Network UGF

TFT Comments
30 April 2021

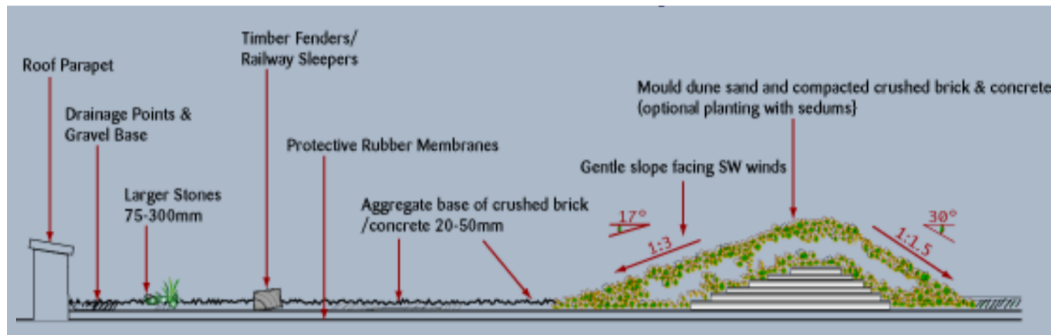
Extensive green roof – 80mm	Intensive green roof 150mm	Intensive green roof 300mm	Rain garden/planting	Gavin's Comments/Queries	Design team responses – 30.04.2021																																													
Roof terrace	145sqm	0	208	0	<p>I presume this is actually the Roof Level (above level 7 of the life-science and level 8 of the office)?</p> <p>I calculate Intensive Green Roof as 208sqm (Office) and 215 (life-science)</p> <p>I calculate Extensive Green Roof as 146sqm (office) and 158 (life-science)</p>	<p>A 145sqm extensive green roof (min 80mm) and 208sqm intensive green roof (300mm) are the minimum areas proposed for both the office and lab science reserved matters applications. Whilst there is no UGF benefit of specifying 300mm substrate depths over 150mm (both are valued at 0.8 within the UGF methodology) the team considered 300mm to provide a greater opportunity for ecological biodiversity and a wider range of planting including tall shrubs and coppices and small trees. This aligns with Derwent's corporate sustainability objectives to deliver biodiversity net gain across their developments.</p> <p>There is further opportunity for green roof provision for the life science building where there is no publicly accessible terrace and additional measures can be incorporated to align this reserve matters application closer with the 0.3 UGF target (as below). Note we have removed ground floor planting and resized the site footprint accordingly which we've explained further in the commentary below.</p> <table border="1" style="width: 100%; border-collapse: collapse;"> <thead> <tr> <th></th> <th>Extensive Green Roof - 80mm</th> <th>Intensive Green Roof - 150mm</th> <th>Intensive Green Roof - 300mm</th> <th>Rain Garden / Soft Planting</th> </tr> </thead> <tbody> <tr> <td>UGF (Urban Greening Factor)</td> <td style="text-align: center;">0.7</td> <td style="text-align: center;">0.8</td> <td style="text-align: center;">0.8</td> <td style="text-align: center;">0.7</td> </tr> <tr> <td>Roof terrace</td> <td style="text-align: center;">512.6m²</td> <td style="text-align: center;">.m²</td> <td style="text-align: center;">219.5.m²</td> <td style="text-align: center;">.m²</td> </tr> <tr> <td>Level 08</td> <td style="text-align: center;">147.1m²</td> <td style="text-align: center;">19.3m²</td> <td style="text-align: center;">.m²</td> <td style="text-align: center;">.m²</td> </tr> <tr> <td>Level GRD</td> <td style="text-align: center;">.m²</td> <td style="text-align: center;">.m²</td> <td style="text-align: center;">.m²</td> <td style="text-align: center;">.m²</td> </tr> <tr> <td>Totals (with UGF applied)</td> <td style="text-align: center;">461.8</td> <td style="text-align: center;">15.4</td> <td style="text-align: center;">175.6</td> <td style="text-align: center;">0</td> </tr> </tbody> </table> <p>UGF = 652.8 / 2,073 = 0.315</p>		Extensive Green Roof - 80mm	Intensive Green Roof - 150mm	Intensive Green Roof - 300mm	Rain Garden / Soft Planting	UGF (Urban Greening Factor)	0.7	0.8	0.8	0.7	Roof terrace	512.6m ²	.m ²	219.5.m ²	.m ²	Level 08	147.1m ²	19.3m ²	.m ²	.m ²	Level GRD	.m ²	.m ²	.m ²	.m ²	Totals (with UGF applied)	461.8	15.4	175.6	0

Ground floor	0	0	0	270	<p>This is off-site – I don't see how this can count towards the UGF – there is also no certainty of its delivery at this stage.</p>	<p>Following clarification with the BRE on areas of assessment as part of calculating ecological improvements in contribution to BREEAM LE04 ecology criteria this area had been included within calculations for the UGF. Derwent are committed to contributing to the enhancement of the ground floor public realm however noting the uncertainty in timeline for delivery we have provided updated UGF calculations without this area. Please be advised the UGF is calculated using the assessed site footprint, by removing the ground floor from the scope of the calculation the footprint must also be updated, which we've highlighted in the table below:</p> <table border="1" style="width: 100%; border-collapse: collapse;"> <thead> <tr> <th colspan="5">Apr-21</th> </tr> <tr> <th></th> <th>Extensive Green Roof - 80mm</th> <th>Intensive Green Roof - 150mm</th> <th>Intensive Green Roof - 300mm</th> <th>Rain Garden / Soft Planting</th> </tr> </thead> <tbody> <tr> <td>UGF (Urban Greening Factor)</td> <td style="text-align: center;">0.7</td> <td style="text-align: center;">0.8</td> <td style="text-align: center;">0.8</td> <td style="text-align: center;">0.7</td> </tr> <tr> <td>Roof terrace</td> <td style="text-align: center;">145.m²</td> <td style="text-align: center;">.m²</td> <td style="text-align: center;">208.m²</td> <td style="text-align: center;">.m²</td> </tr> <tr> <td>Level 08</td> <td style="text-align: center;">147.1m²</td> <td style="text-align: center;">19.3m²</td> <td style="text-align: center;">.m²</td> <td style="text-align: center;">.m²</td> </tr> <tr> <td>Level GRD</td> <td style="text-align: center;">.m²</td> <td style="text-align: center;">.m²</td> <td style="text-align: center;">.m²</td> <td style="text-align: center;">.m²</td> </tr> <tr> <td>Totals</td> <td style="text-align: center;">292.1</td> <td style="text-align: center;">19.3</td> <td style="text-align: center;">208</td> <td style="text-align: center;">0</td> </tr> <tr> <td>Building Footprint (excluding pavement)</td> <td colspan="4" style="text-align: center;">2073</td> </tr> <tr> <td>UGF</td> <td colspan="4" style="text-align: center;">0.19</td> </tr> </tbody> </table>	Apr-21						Extensive Green Roof - 80mm	Intensive Green Roof - 150mm	Intensive Green Roof - 300mm	Rain Garden / Soft Planting	UGF (Urban Greening Factor)	0.7	0.8	0.8	0.7	Roof terrace	145.m ²	.m ²	208.m ²	.m ²	Level 08	147.1m ²	19.3m ²	.m ²	.m ²	Level GRD	.m ²	.m ²	.m ²	.m ²	Totals	292.1	19.3	208	0	Building Footprint (excluding pavement)	2073				UGF	0.19

There is very little information provided in the submitted Outline and RM documents (Design & Access Statements / Sustainability statements) about the type of living roofs to be provided (species, habitat types etc) – other than the depth of the substrate. The Ecology report presented with the Outline provides recommendations – and states that the living roof specifications should be drawn up by a company with a proven track record in delivering these features in London. This doesn't seem to have been developed any further and the Ecology Report recommendations are not referenced in the RM applications. – As the project is at a concept design stage a preliminary ecological assessment has informed the available areas for green roofs and recommendations to be developed further during the developed design. The intensive green roof provision provides flexibility for the team to develop an appropriate ecological strategy and we will follow the recommendation within the report to work with a landscape architect (to be appointed) and the suitably qualified ecologist during spatial coordination and technical design stages to draw up living roof specifications.

While we can leave confirmation of species, maintenance, confirmation of build-up etc to a detailed condition, it is important that we have greater clarity about the scope/specification of the living roofs and whether they will be multi-functional (biodiverse/biosolar/green-blue) or more benign (sedum). Camden's CPG (Energy Efficiency and adaption – chapter 10) is clear that our preference is for developments to incorporate biodiverse green roofs rather than sedum roofs, as sedum roofs provide limited biodiversity value. Overall the scheme seems to provide quite limited contribution to biodiversity. All green roofs proposed would be biodiverse, GRO Code 2014 compliant (min 80mm substrate) allowing for a greater variety of herbaceous plants, and habitat creation (an example illustration provided below) over a sedum blanket which is recognised as offering limited ecological value. This is reflected in the UGF methodology attributing a value of 0.3 to extensive sedum blankets. We have not included any of these roofs within our proposals as seen in the UGF calculations with proposed substrate depths allowing for a wide variety of ecological features to enhance on-site biodiversity.

With the ongoing work by Piercy & Co looking at the top level of accommodation now is the time to re-examine the potential of the site to deliver a greater contribution to biodiversity and to significantly improve the SUDs performance of the site as raised below, without needing recourse to a basement attenuation tank.

The explanation presented in the feedback to the GLA (row 15 of "schedule of responses to comments received 1/4/21") about the green roof being constrained by structure of the top floor accommodation and the LVMF breach need re-visiting:

- It strikes me that the notional extensive green roof at level 7/8 along the edges could be reconfigured as more biodiverse and potentially used to extend the blue roof area (in a combined blue/green system).

- The top floor accommodation is only about 3% of the total accommodation in the building – so it strikes me that arguments about the carbon cost of the structural implications needed to support a more biodiverse living roof are pretty marginal.

- The issue about LVMF breach could be remedied by dropping floor-ceiling heights throughout the building by an almost imperceptible 10mm, as mentioned below. This would bring the added advantage of addressing HEs and the GLAs concerns about the LVMF.

- Adding more depth to the roof structure would also allow scope for more visually interesting and biodiverse planting for the upper office roof terrace – which would mean that the terrace could have a much greener character without the need to resort to planters (which raise further issues with LVMF). The limited visual biodiversity benefits achievable from sedum on the 80mm substrate on this level and the indication of only 20sqm of planters on the roof terrace below seem a bit behind the curve on the contemporary emphasis on adding biophilia and greening to commercial amenity spaces for the wellbeing benefits of employees and occupants.

We need to see a more holistic approach to addressing these issues – before final decisions are made about the upper floor designs.

Extensive Green Roof - 80mm	Intensive Green Roof - 150mm	Intensive Green Roof - 300mm	Rain Garden / Soft Planting																																															
UGF (Urban Greening Factor)	0.7	0.8	0.8	0.7																																															
Roof terrace	512.6m ²	.m ²	219.5.m ²	.m ²																																															
Level 08	147.1m ²	19.3m ²	.m ²	.m ²																																															
Level GRD	.m ²	.m ²	.m ²	.m ²																																															
Totals (with UGF applied)	461.8	15.4	175.6	0																																															
Level 08	147.1sqm	19.3	0	0	<p>Is this the green area on the sides of the top floor of accommodation?</p> <p>Can this not be provided as Intensive Green roof or GreenBlue roof – seeing as how it is not limited by considerations of LVMF height and will need to be contained by a parapet buildup.</p>	<p>Following review the team have confirmed that a 150mm substrate at level 8 can be accommodated without significant structural alterations which would improve the UGF category of this area from 0.7 to 0.8 and result in an overall UGF improvement of 0.005.</p>

Apr-21																																																			
	Extensive Green Roof - 80mm	Intensive Green Roof - 150mm	Intensive Green Roof - 300mm	Rain Garden / Soft Planting																																															
UGF (Urban Greening Factor)	0.7	0.8	0.8	0.7																																															
Roof terrace	145.m ²	.m ²	208.m ²	.m ²																																															
Level 08	147.1m ²	19.3m ²	.m ²	.m ²																																															
Level GRD	.m ²	.m ²	.m ²	.m ²																																															
Totals	292.1	19.3	208	0																																															
Building Footprint (excluding pavement)	2073																																																		
UGF	0.19																																																		
UGF contribution	0.079	0.006	0.065	0.074																																															
Total	0.15				The baseline UGF is looking very poor when the off-site planting is not included.	The above calculation confirms an UGF of 0.19, above the 0.15 suggested in your previous clarification email which referred to a 2,566sqm site footprint which includes ground floor public realm.

Please refer to Piercy & Co's email for response on the following points
